AP - 46

**STAGE 1 & 2
WORKPLANS**

STAGE 2 ABATEMENT PLAN

EME JCT. K-6 SITE (AP-46)
T20S, R37E, SECTION 6, UNIT LETTER K
LEA COUNTY, NEW MEXICO

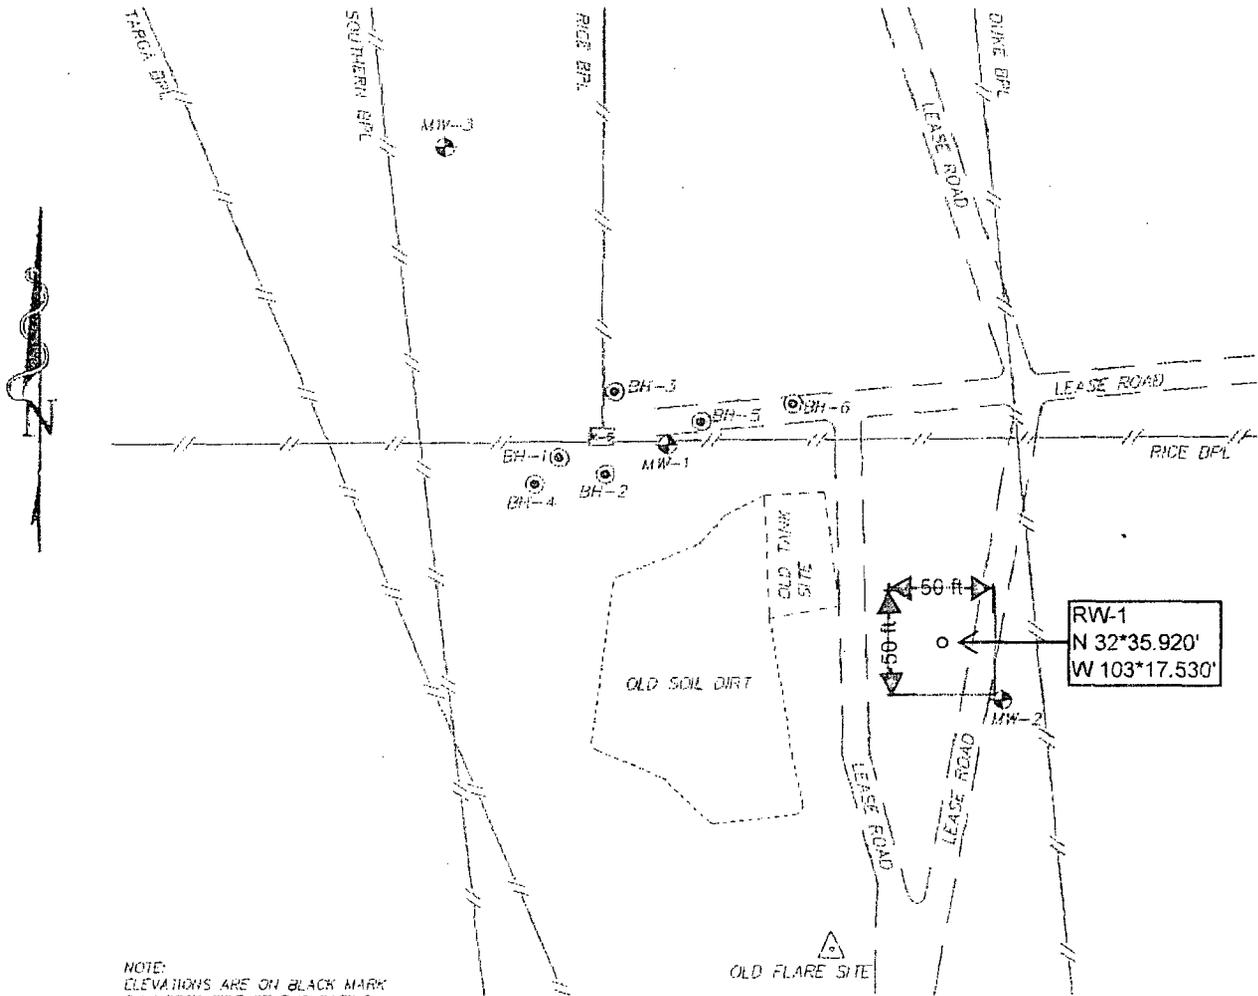
I would like to make an amendment to the Stage 2 abatement plan for AP-46 dated 5-6-08 on Page 13, 2nd paragraph. Red is deleted words and blue is added words. If you have any questions or concerns please contact me.

Installation of a groundwater recovery system is contingent on successful application with the New Mexico Office of the State Engineer and landowner agreement in accordance with NMSA 1978 Article 72-12-3(B). It will likely be necessary to install a 4 inch diameter recovery well near MW-1 completed to the base of the aquifer (about 60 ft bgs). The conceptual design and specifications of the groundwater recovery system include a submersible or positive displacement pump capable of discharging at a minimum rate of 1 gpm. Due to the remoteness of the site the necessary power supply for the system will likely be provided by a solar powered battery. Flow rate, total volume, and chloride content of the recovered groundwater will be measured prior to discharge into the EME SWD system being utilized in pipeline maintenance operations.
